Florida Greenbook

Sub-committee Meeting

Chapter 4 – Roadside Design

October 30, 2025
1:00 PM – 2:00 PM

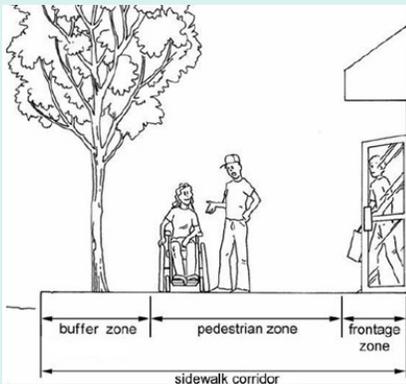
- Clear zone distances following FHWA's 2005 Barrier Guide for Low Volume and Low Speed Roads
- Inclusion of AASHTO Roadside Design Guide (RDG) edition
- Distinction between lateral offset, clear zone, and border width concepts with a figure

Committee – We will create or adapt a figure that differentiates clear zone, lateral offset, and border width/area. Something like this –

Figure 4-9. Location of Guardrail

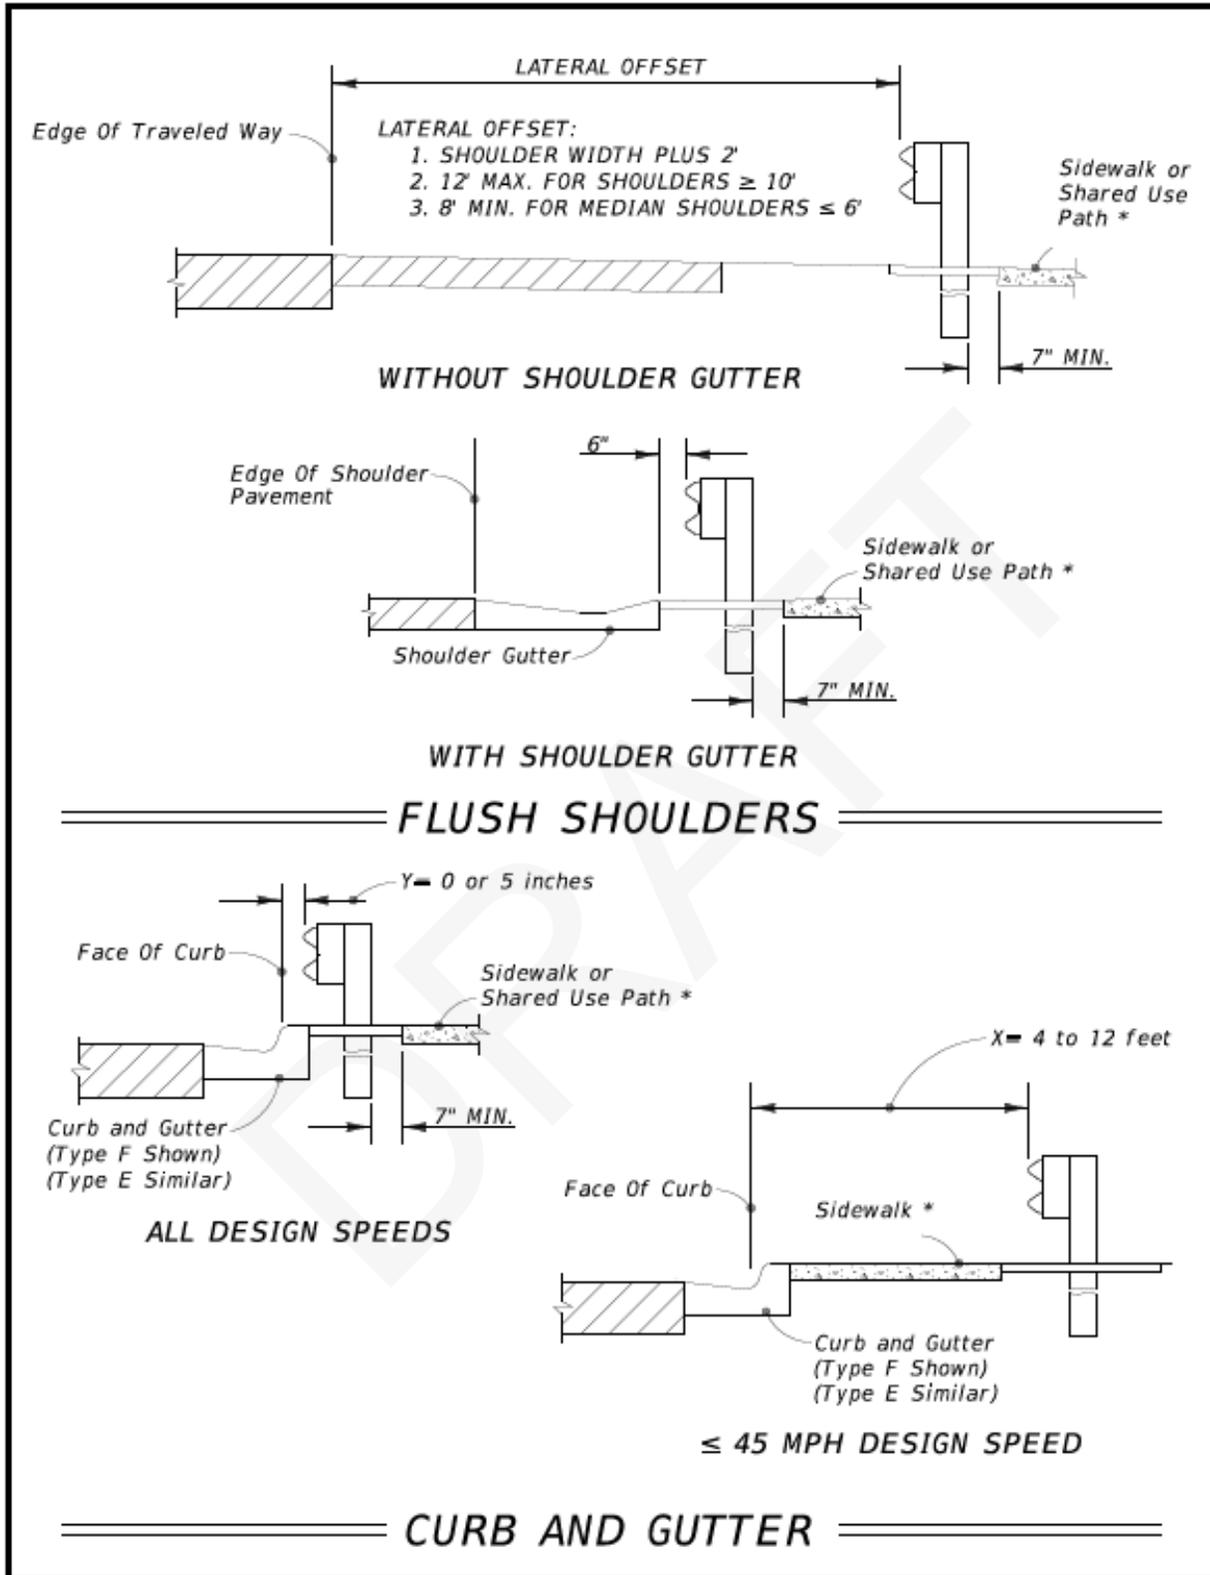
Committee – Note for the following figures (and other figures in this chapter): we will work with Daniel Eichler to ensure all the drawings are from the pending 2026 FDM and have any modifications necessary to be applicable to the Greenbook.

Figure 4-11. Approach Terminal Usage When End of Guardrail Is Within Clear Zone of Approaching Near (Top) and Far (Bottom) Lane (Two-Lane, Two-Way Road Shown)

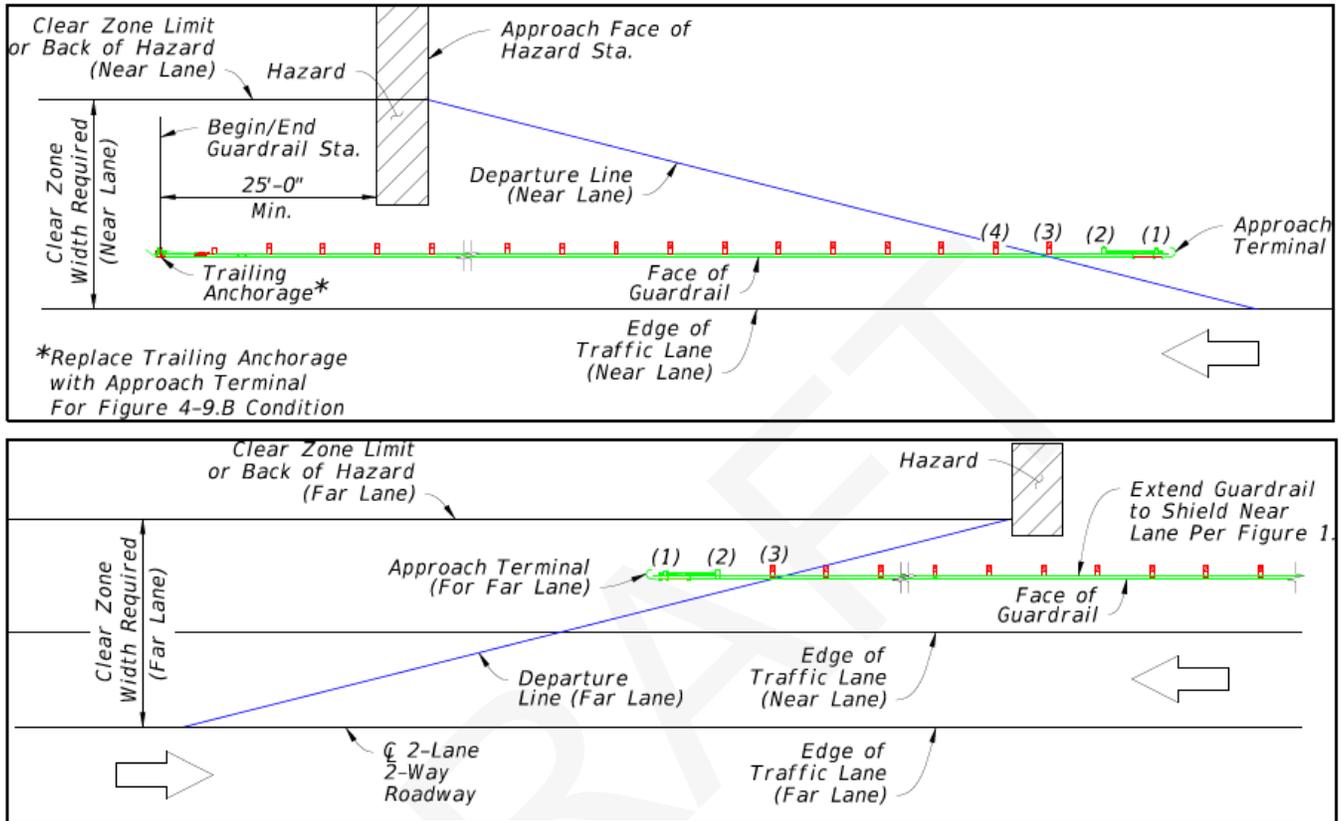
Committee – Figure 4-11 currently refers to Figure 4-9 B and will be corrected when we begin updating all the figures.
